UNITED STATES PATENT AND TRADEMARK OFFICE

APPLICATION NO.	FILING DATE	FIRST NAMED INVENTOR	ATTORNEY DOCKET NO.	CONFIRMATION NO.
10/567,134	02/06/2006	Masahiko Igarashi	025416-00026	4553
4372 7590 06/26/2008 ARENT FOX LLP 1050 CONNECTICUT AVENUE, N.W. SUITE 400 WASHINGTON, DC 20036				
EXAMINER GARCIA, ERNESTO				
ART UNIT 3679		PAPER NUMBER		
NOTIFICATION DATE 06/26/2008		DELIVERY MODE ELECTRONIC

Office Action Summary

DETAILED ACTION

Fig. 1

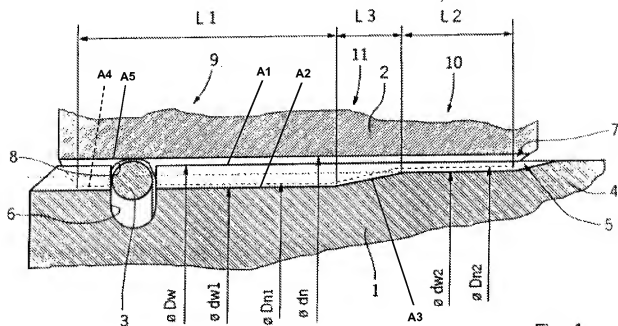
Regarding claim 1, Beigang discloses, in Figures 1 and 2, a mechanism comprising a shaft **1** and a hub **2**. The hub **2** is disposed around the shaft **1** while holding a shaft tooth section **5** formed on the shaft **1**. The hub **2** has a hub tooth section **7** in engagement with the shaft tooth section **5**. The shaft tooth section **5** has a crowned peak having a varying tooth thickness and a valley **A2** having an outside diameter varying from an end thereof toward a shaft shank of the shaft **1**. The hub tooth section **7** has a straight peak **A4** and a valley **A5**. The straight peak **A4** has a constant tooth thickness and an inside diameter varying from an end thereof toward the shaft shank. The valley **A5** of the hub tooth section **5** has a constant inside diameter in the axial direction of the shaft **1**.

Regarding claim 2, a changing point of the outside diameter of the valley **A2** of the shaft tooth section **5** and a changing point of the inside diameter of the peak **A4** of

the hub tooth section **7** are set in respective positions which are offset from each other in the axial direction of the shaft **1** (see towards the left side of Figure 1 which is the front of the joint).
